Addendum #2

Bid Opportunity: 23-7362-RFT

**Waterloo-Oxford District Secondary School –
Family Studies Renovation & HVAC Upgrades**

GREENHOUSE, POTTING, & WORK ROOM LAYOUTS & DETAILS

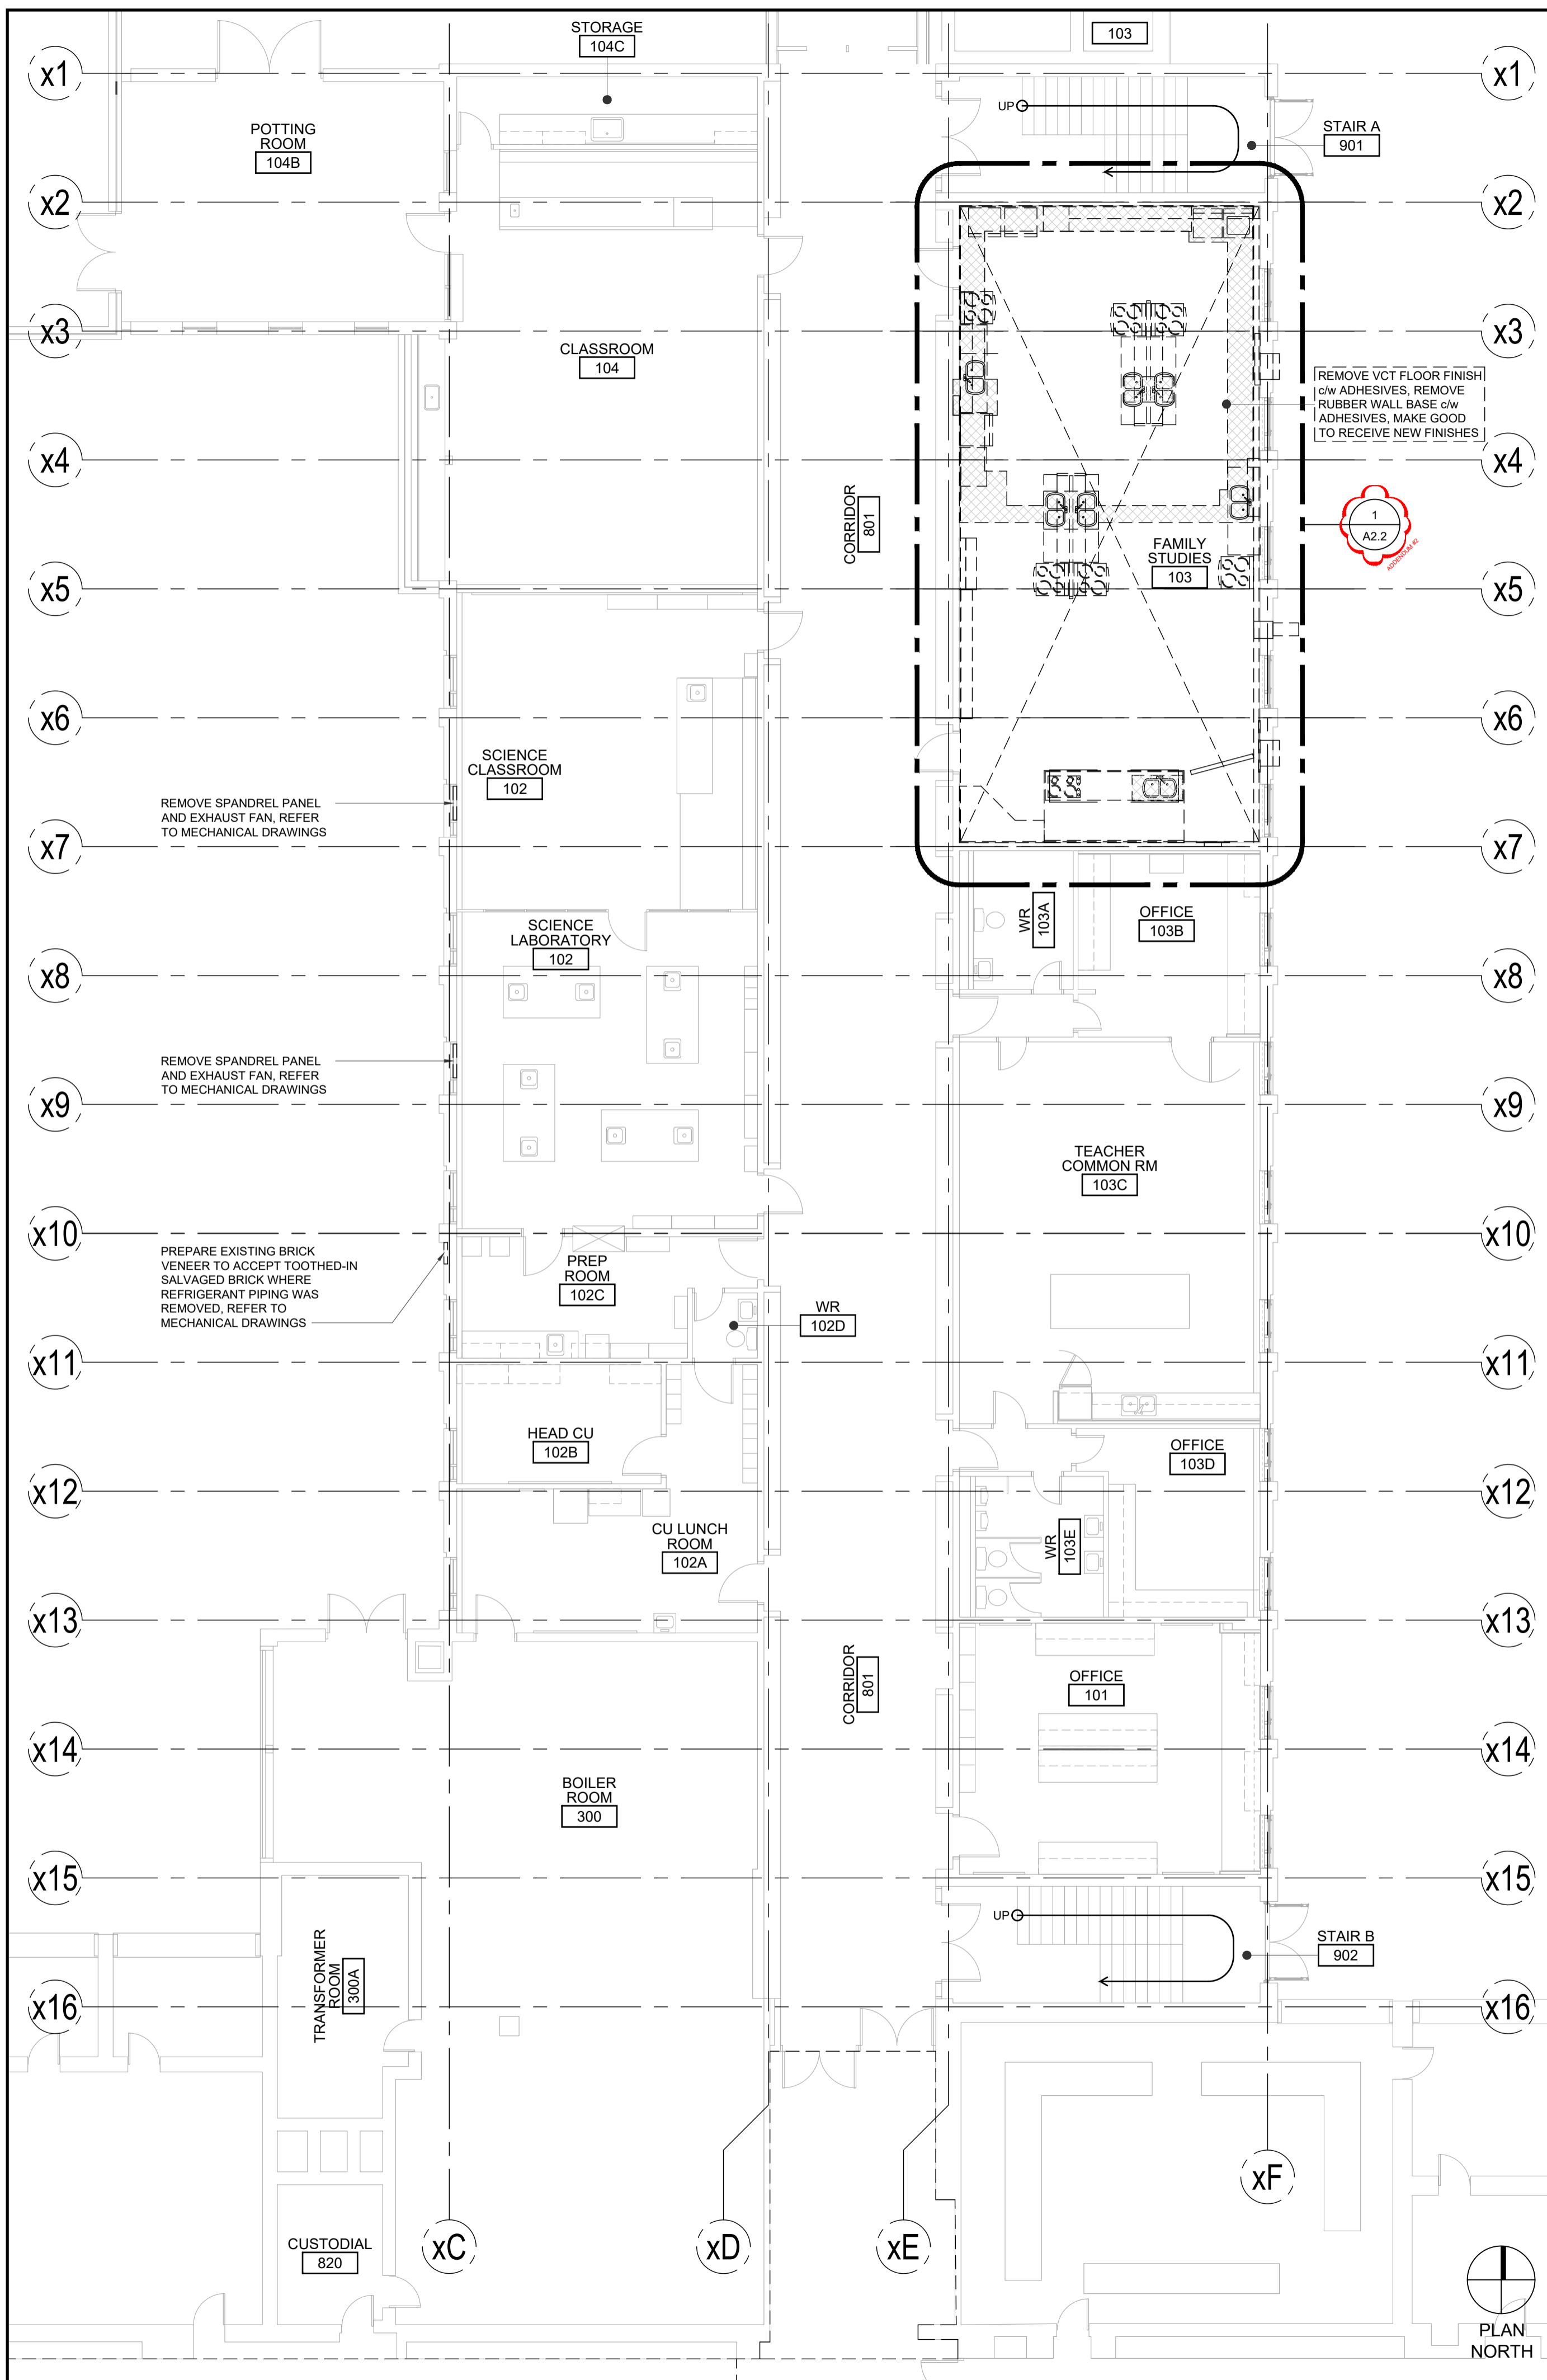
On Drawing SP1.1 the sprinkler outline for the ground floor includes the green house. Are there any drawings for the green house? Is the green house heated all year?

Refer to attached Record Drawing of the Greenhouse, which may not represent existing conditions. The Greenhouse is heated year-round.
